VIRGINIA ELECTRIC AND POWER COMPANY
RICHMOND, VIRGINIA 23261

June 22, 2000

VIRGINIA ELECTRIC AND POWER COMPANY
NORTH ANNA POWER STATION UNITS 1 AND 2
PROPOSED TECHNICAL SPECIFICATIONS CHANGES
REQUESTS FOR EXEMPTION PER 10 CFR 50.60(b)
REACTOR COOLANT SYSTEM PRESSURE/TEMPERATURE LIMITS
LTOPS SETPOINTS, AND LTOPS ENABLE TEMPERATURES

Figure 3.4-2 — North Anna Unit 1
Reactor Coolant System Heatup Limitations

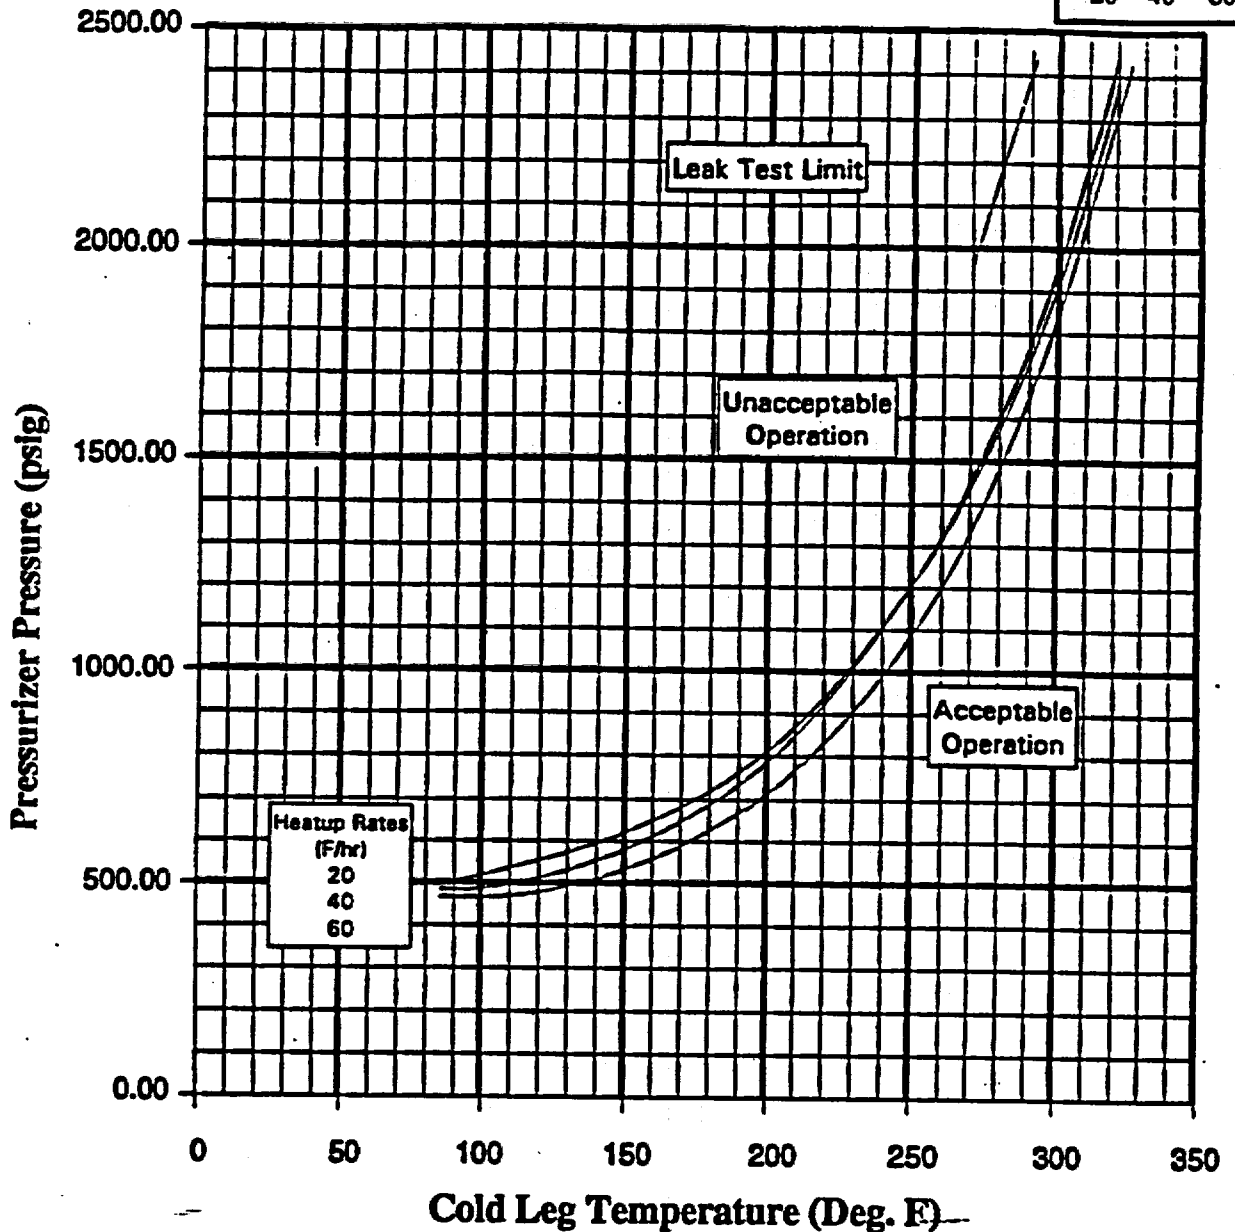
Figures 3.4-2 and 3.4-3, Reactor Coolant System Heatup and Cooldown Limitations: The “material property basis” and the cumulative core burnup applicability limits on North Anna Units 1 and 2 Figures 3.4-2 and 3.4-3 are being modified to reflect the revised design analysis for the reactor coolant system pressure/temperature operating limits.

The reactor vessel materials have been tested to determine their initial RT_{NDT} . Reactor operation and resultant fast neutron ($E > 1$ Mev) irradiation will cause an increase in the RT_{NDT} . An adjusted reference temperature, based upon the fluence and copper content of the material in question, can be predicted using US NRC Regulatory Guide 1.99, Revision 2. The heatup and cooldown limit curves (Figure 3.4-2 and Figure 3.4-3) include predicted adjustments for this shift in RT_{NDT} at the end of 30.7 EFPY. The reactor vessel beltline region material properties are listed on Figures 3.4-2 and 3.4-3.

**Figure 3.4-2 — North Anna Unit 2
Reactor Coolant System Heatup Limitations**

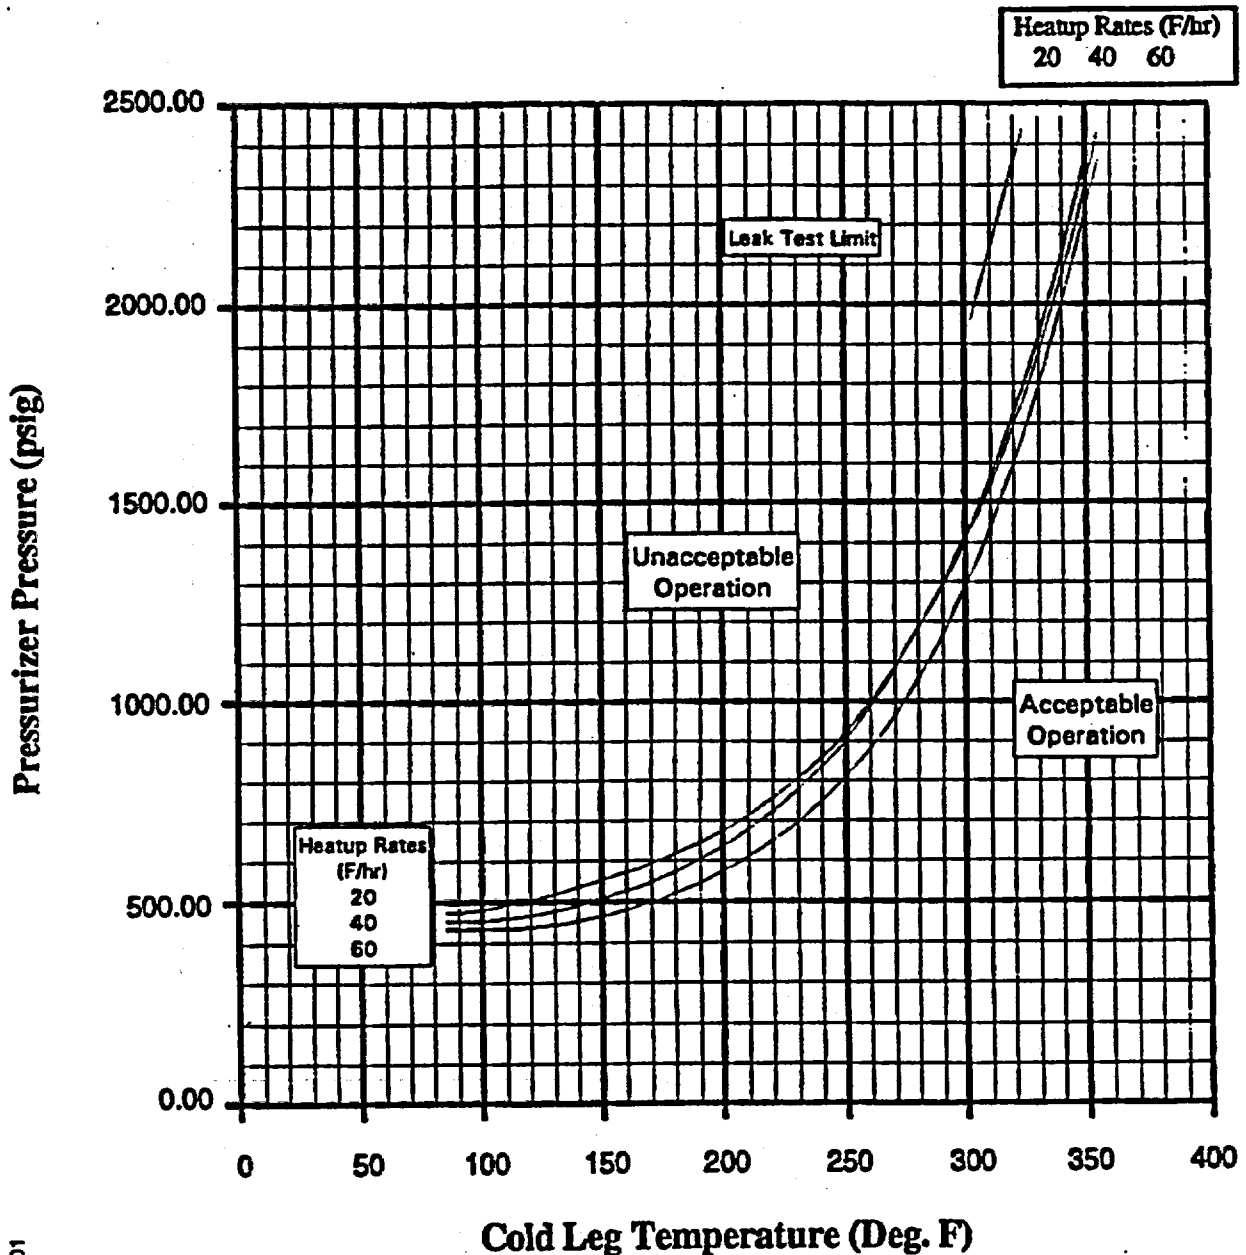
The heatup limit curve, Figure 3.4-2, is a composite curve which was prepared by determining the most conservative case, with either the inside or outside wall controlling, for any heatup rate up to 60°F per hour. The cooldown limit curves of Figure 3.4-3 are composite curves which were prepared based upon the same type analysis with the exception that the controlling location is always the inside wall where the cooldown thermal gradients tend to produce tensile stresses while producing compressive stresses at the outside wall. The heatup and cooldown curves of Figures 3.4-2 and 3.4-3 conservatively bound the design basis heatup and cooldown curves, which were based upon a 1/4-T RT_{NDT} value of 218.5°F and a 3/4-T RT_{NDT} value of 195.6°F. These RT_{NDT} values conservatively bound the predicted reactor vessel beltline RT_{NDT} values for North Anna Unit 2 operation through 34.3 EFPY.

Material Property Basis
Limiting ART at 34.3 EFPY: 1/4-T, 218.5°F
 3/4-T, 195.6°F
